Project	IEEE 802.16 Broadband Wireless Access Working Group < http://ieee802.org/16 >
Title	Corrections to ACR for 802.16-2004
Date Submitted	2005-07-19
Source(s)	Darcy Poulin [mailto:dp@sige.com] SiGe Semiconductor
Re:	Response to Sponsor Ballot on IEEE802.16-2004/Cor1/D3 document
Abstract	This document describes the reasons why ACR is incorrect in the current version of the 802.16 standard.
Purpose	This document is background material for a correction to ACR required in 802.16-2004
Notice	This document has been prepared to assist IEEE 802.16. It is offered as a basis for discussion and is not binding on the contributing individual(s) or organization(s). The material in this document is subject to change in form and content after further study. The contributor(s) reserve(s) the right to add, amend or withdraw material contained herein.
Release	The contributor grants a free, irrevocable license to the IEEE to incorporate material contained in this contribution, and any modifications thereof, in the creation of an IEEE Standards publication; to copyright in the IEEE's name any IEEE Standards publication even though it may include portions of this contribution; and at the IEEE's sole

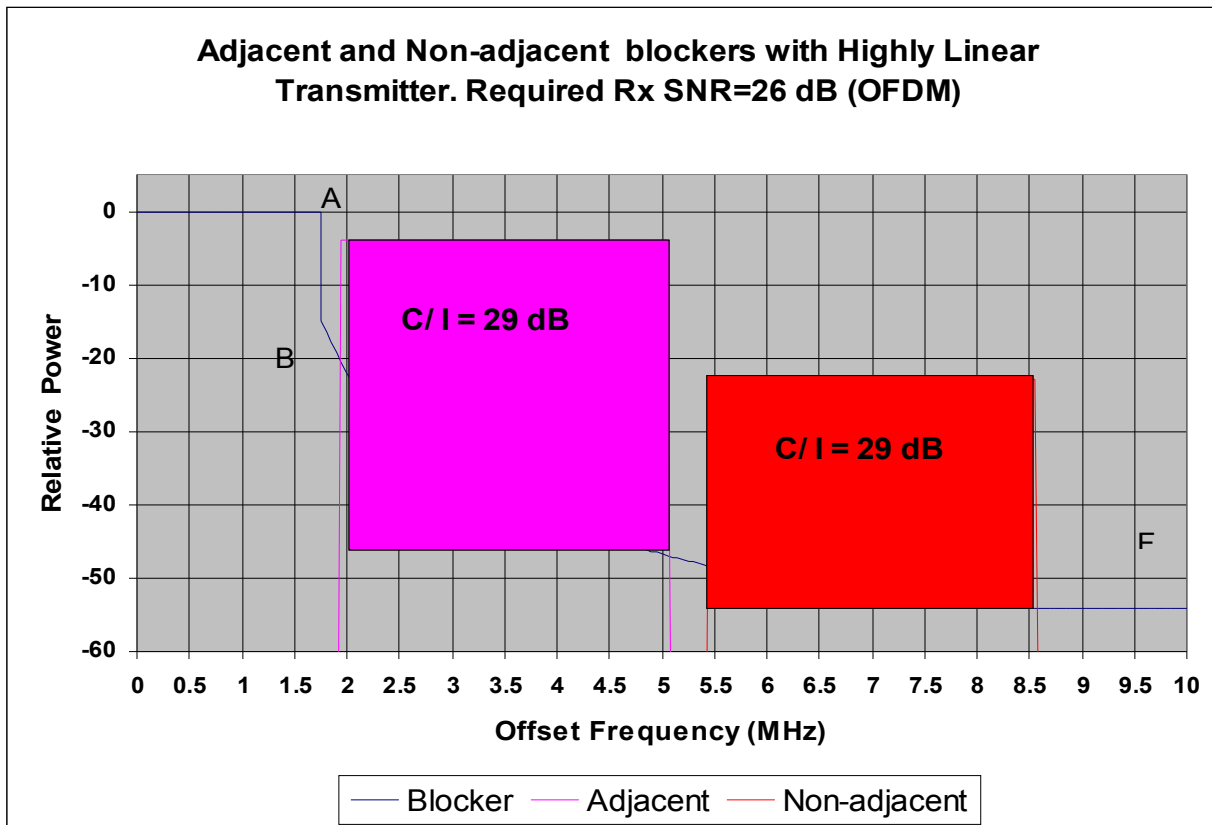
After discussion with a number of conference attendees, we have decided to leave the ACR specifications as they currently are (except that we will correct them so that the difference between 64QAM and 16QAM is 6 dB, and change the OFDMA requirement to take into account the fact that the Rx SNR is 1 dB lower than for OFDM), and we will add a section to specify that ACI must be measured using a highly linear “test transmitter” with an enhanced spectral mask.

The reason for using a “test transmitter” is that we want to isolate the ACR specification to the receiver only. ACR contributions due to emissions from a real transmitter leaking into the desired channel will be dealt with separately through a recommended spectral emissions mask.

When measuring ACR, we wish to ensure that the alternate and adjacent channel power that leaks into the desired channel is at a low enough level so that the resulting C/I is 3 dB below the required Rx SNR. We therefore propose that the alternate or adjacent transmitted signal from the highly linear test transmitter is a modified version of the ETSI Type G mask. Specifically, the transmitter must meet or exceed the following mask:
A=0 dB; B= -15 dB; C=-36 dB; D= -42dB; E= -54dB; F=-54dB.

Please see ETSI EN301021 for the definition of the location of the frequency offsets.

Note that this transmitter is an “ideal” source, and is used only for test purposes. It will likely be a dedicated piece of test equipment.
The ACR specifications must be met for all channel bandwidths.

Assuming that the transmitter meets this mask, energy leaking into the desired channel from adjacent or non-adjacent channel will be 3 db below the required SNR. This will isolate any ACI issues specifically to the receiver.
